[Docket No. FAA-2015-7527; Directorate Identifier 2015-NM-094-AD; Amendment 39-18686; AD 2016-21-05]

Airworthiness Directives; The Boeing Company Airplanes

ACTION: Final rule.

Figure 1 to paragraph (h) of this AD: Wiring Installation - Right Engine Fuel Spar Valve

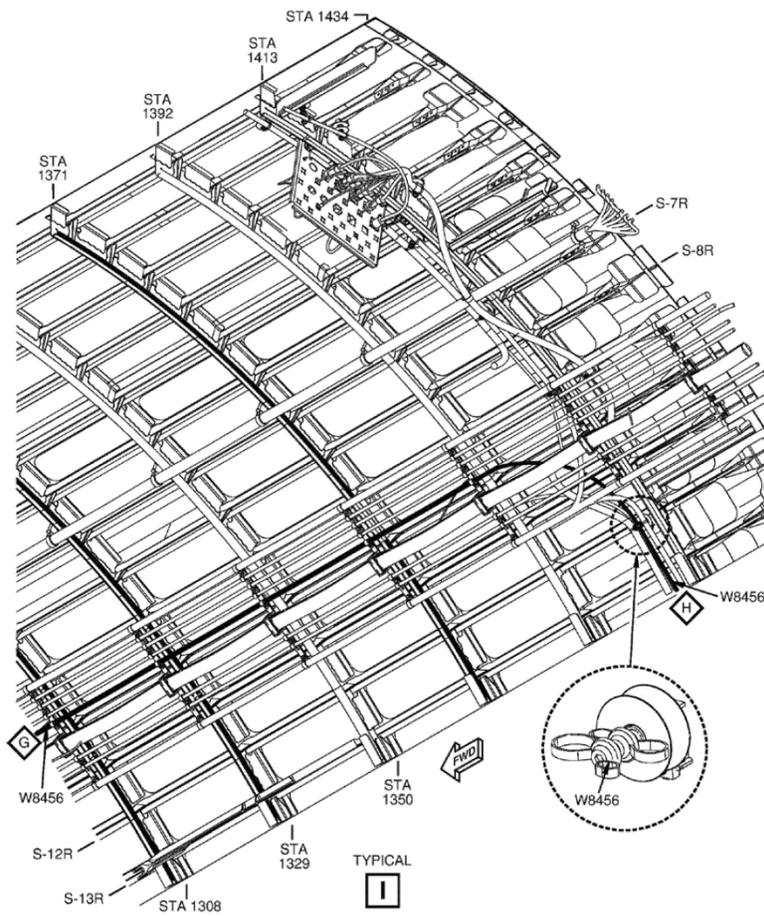
We partially agree with the commenter's request. We cannot include Boeing Service Bulletin Information Notice 777-28-0061, IN 03, dated November 16, 2015, as an appropriate source of service information in this AD because it is not an FAA-approved document. However, we acknowledge that for certain airplanes, Figure 22, Sheet 9, of Boeing Special Attention Service Bulletin 777-28-0061, Revision 2, dated May 4, 2015, includes an editorial error, which shows incorrect wire routing. Boeing Service Bulletin Information Notice 777-28-0061, IN 03, dated November 16, 2015, allows for a modification of Group 2 airplanes that meets the requirements of the AD without an additional burden to operators. We have included a corrected figure in paragraph (h) of this AD to address this issue.

(1) Where Boeing Special Attention Service Bulletin 777-28-0061, Revision 2, dated May 4, 2015, specifies to use Figure 22, Sheet 9, for the wiring installation of the right engine fuel spar valve, this AD requires using figure 1 to paragraph (h) of this AD.
